**FINAL DRAINAGE REPORT
FOR
RETREAT AT TIMBERRIDGE
FILING NO. 1**

Engineering Review

**EPC Planning & Community
Development Department**

PCD Project No. SF-19-xx009

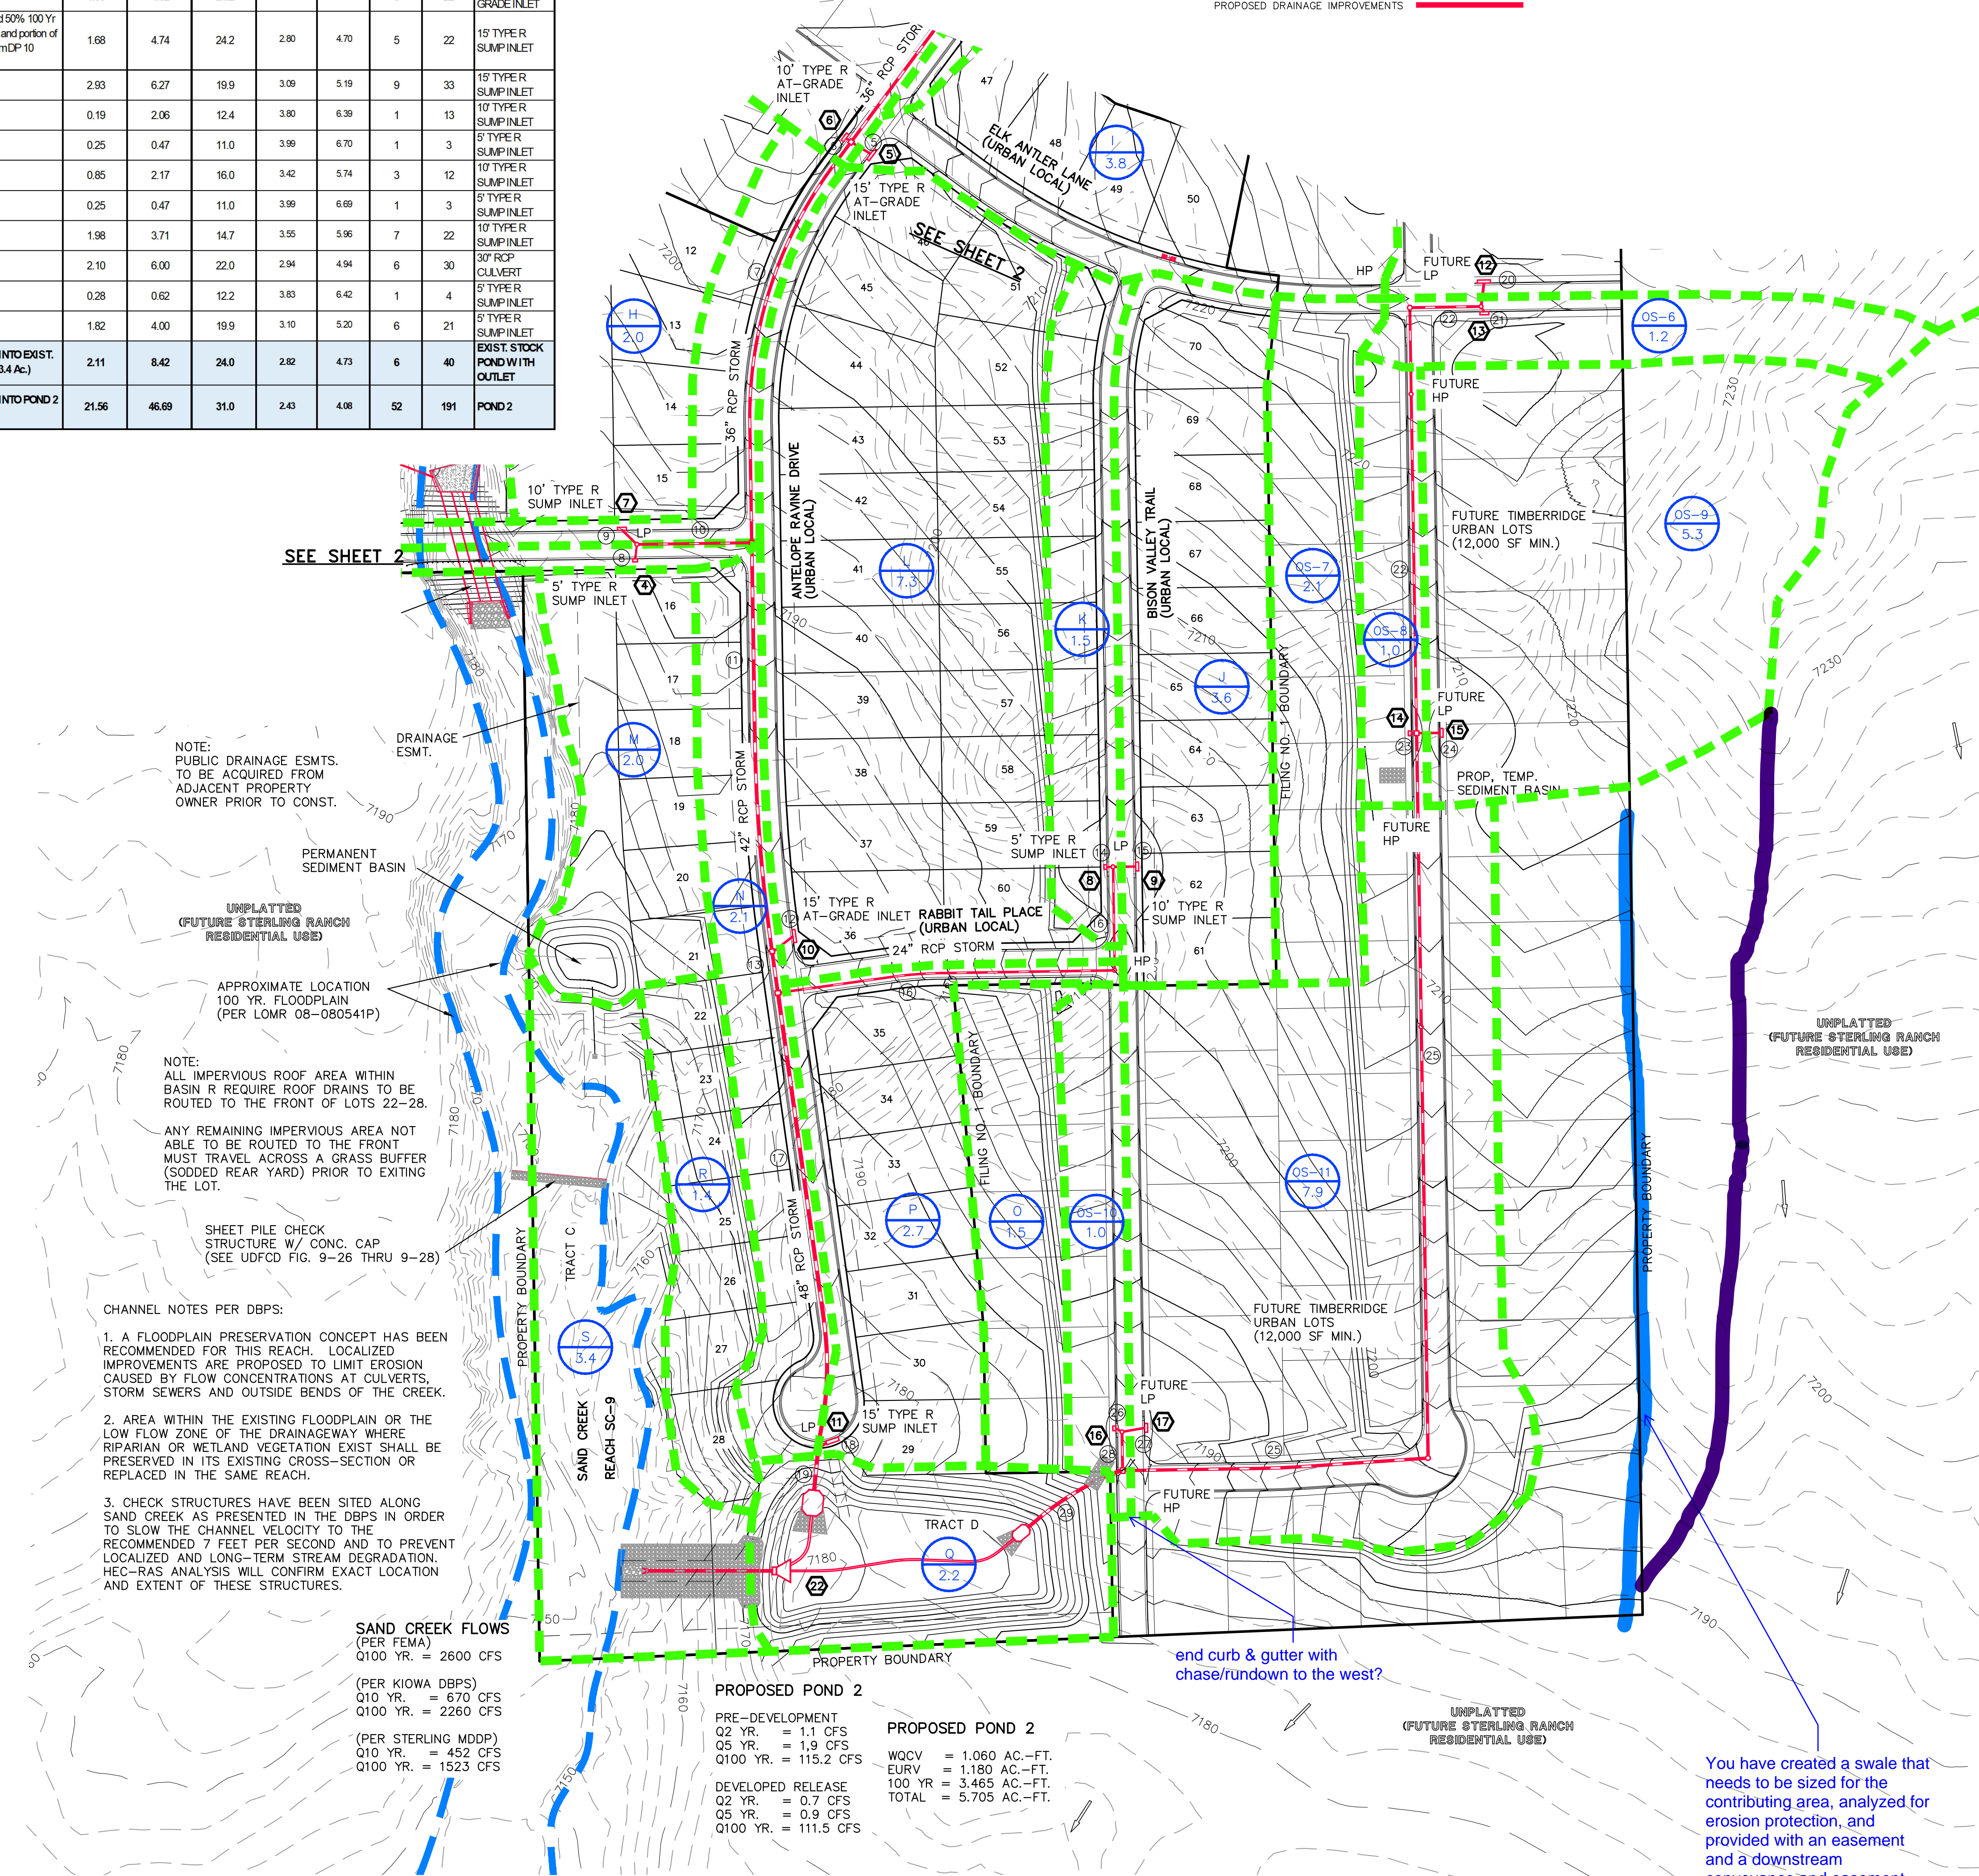
Provide conveyance

DP 20, culvert, TSB?

should swale go further east?

Does floodplain remain the same with culvert?
